Remarks:

ANNOTATED SHEET SHOWING CHANGES

Fig. 3

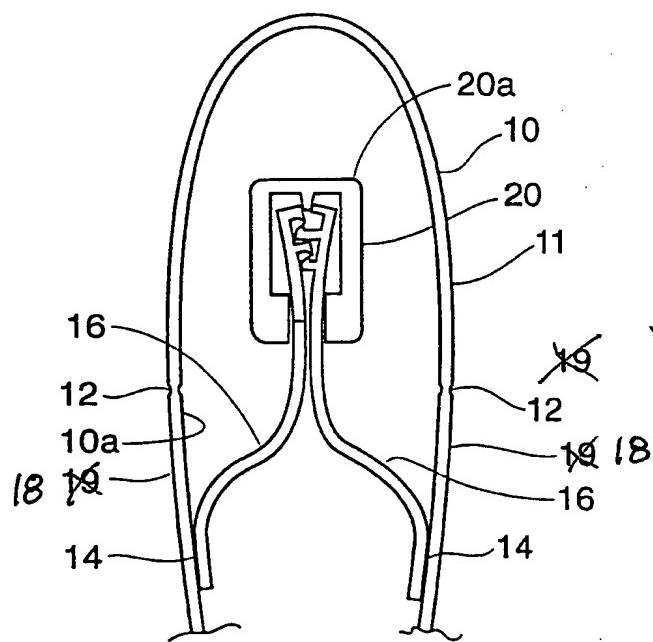
Fig. 3 is being amended to eliminate the use of the reference numeral "19" to refer to a component. Both a marked-up copy of the amended figure and a replacement drawing sheet are being submitted. In the specification, paragraph 81 is also being amended to make the corresponding changes in the specification. This change is being made due to a related application which includes the same figures plus a number of additional figures using the reference numeral "19" in two figures, the second of which is not included in the present application.
